STAFF REPORT: 10-9-2019 MEETING
APPLICATION NUMBER: 19-6490
ADDRESS: 791 SEMINOLE
HISTORIC DISTRICT: INDIAN VILLAGE
APPLICANT: YURI DADO
DATE OF COMPLETE APPLICATION: 11/13/2019
DATE OF STAFF SITE VISIT: 12/4/2019

SCOPE: INSTALL NEW WINDOWS

Photos of building after 4-2019 unapproved work

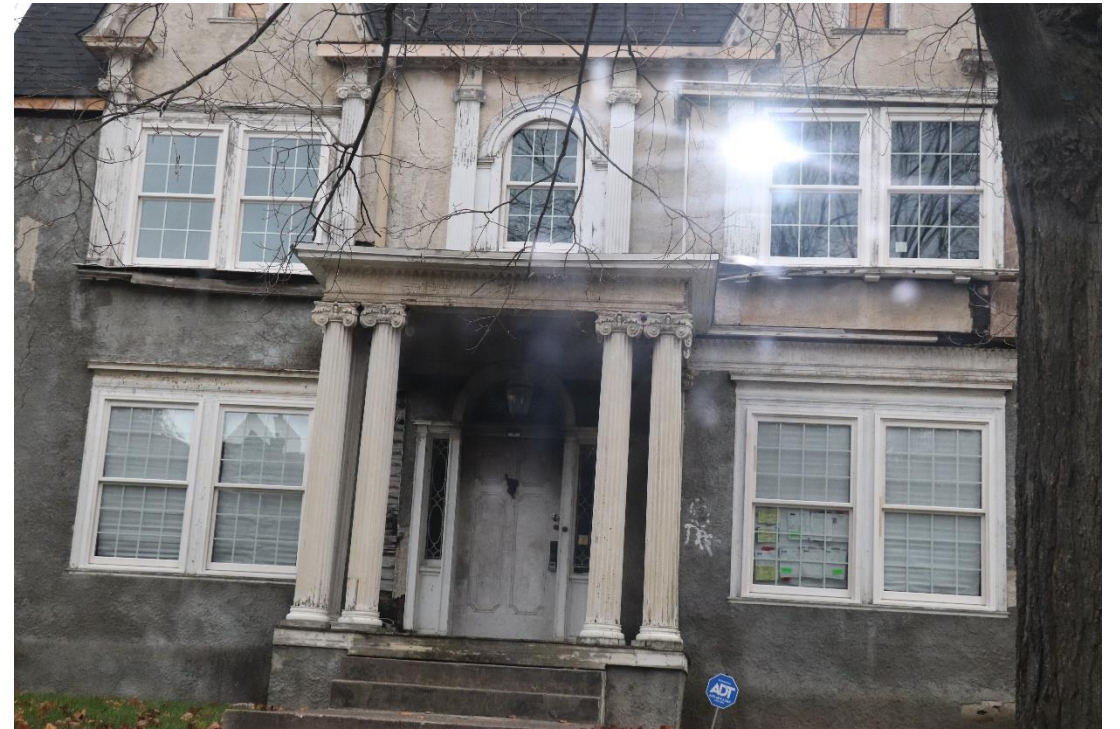
- On 4/30/2019, staff forwarded a report to BSEED that the following work had been completed without HDC approval OR permit:
 - The installation of unfinished plywood fascia boards The addition of the plywood/OSB siding at the front, rear, and side elevations

- Rebuilding of the rear porch
 - The installation of a plywood board at the rear garage fascia
- On 4/30/2019, HDC staff contacted one of the property owners (Yuri Dado) and discussed the ongoing violations at the property. Specifically, staff offered to help them through the process, but noted that they should stop by asap so that HDC staff could get them the approval they needed in order to undertake any exterior work outside of the approved and permitted asphalt shingle installation.

- The fascia at the home and garage roofs shall be and restored to their historic appearance using new wood to match the historic in detailing, dimension, and profile

- All existing plywood from the home's exterior walls shall be removed and new stucco added to match the historic appearance
- Replace all existing non-historic wood windows and replace with new wood windows, to match the original in dimension, profile, operation and light configuration. The new windows must be true divided light or simulated divided lite (grid applied to the exterior surface of the glass).

Photos after 9-2019 unapproved window installation

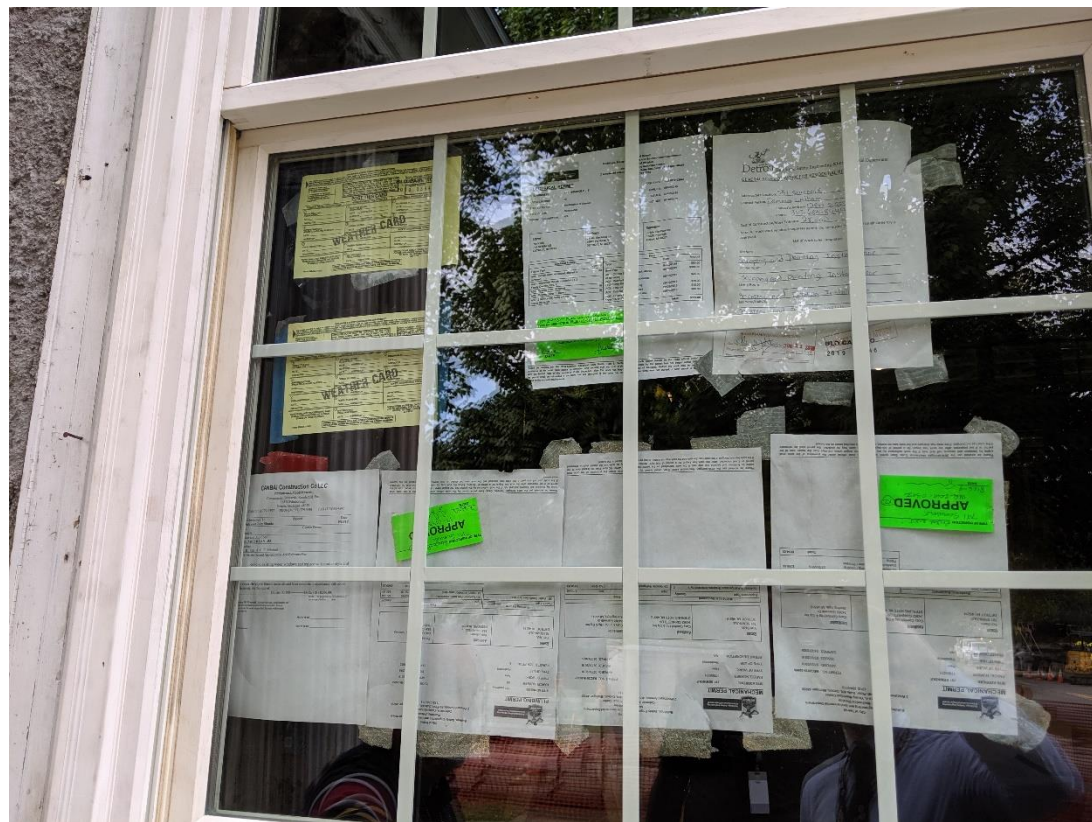
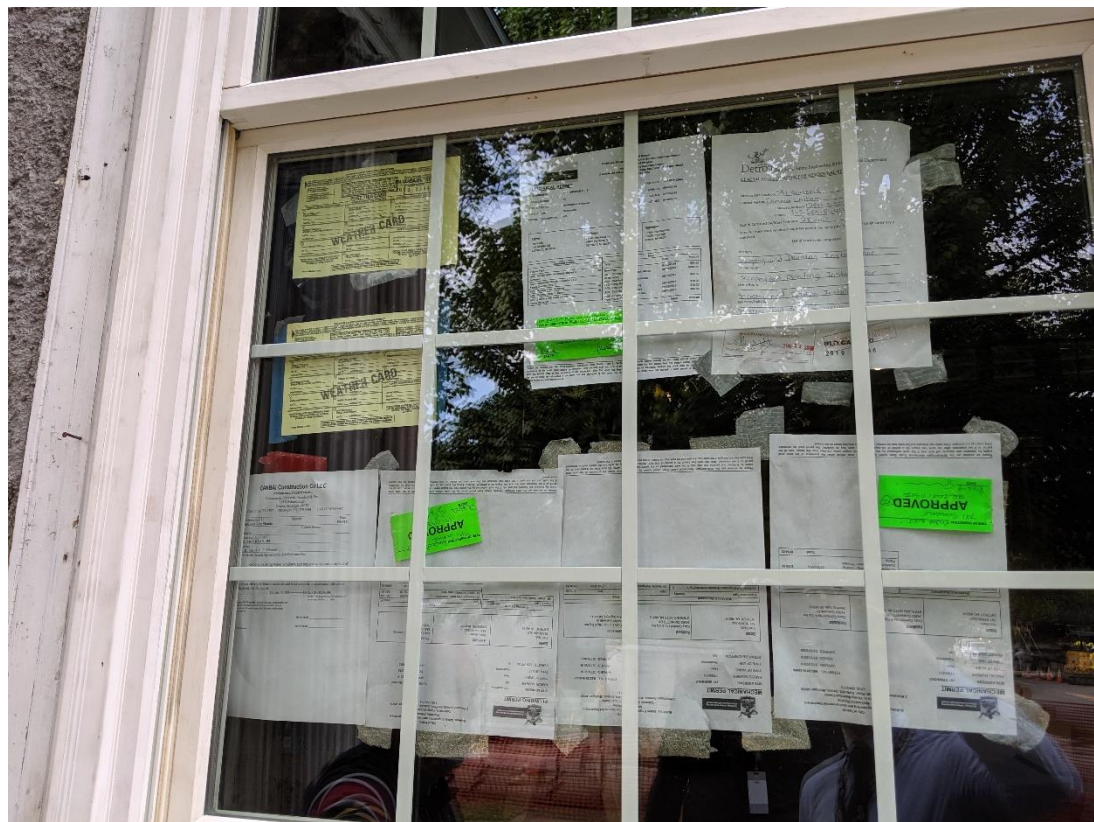
- On 9/13/2019, HDC staff were made aware that the original windows at the property were being removed and replaced. This work was undertaken without permit and/or HDC approval. Please see the **attached photos** of the unapproved windows. Please see the attached photos

- The light configuration of the new windows do not match the old/original
 - The grids at the new windows are between the glass
 - Many of the windows are improperly fitted within their opening. Plywood has been used to infill the gaps in the opening.

- The new windows are not properly recessed with their openings
 - HDC field investigations revealed that leaded glass windows were removed from the building.

- Where windows are missing, new wood windows, to match the original in dimension, profile, operation and light configuration. The new windows must be true divided light or simulated divided lite (grid applied to the exterior surface of the glass). The existing window trim./brickmould must be retained and repaired (where necessary) with new wood to exactly replicate the original.
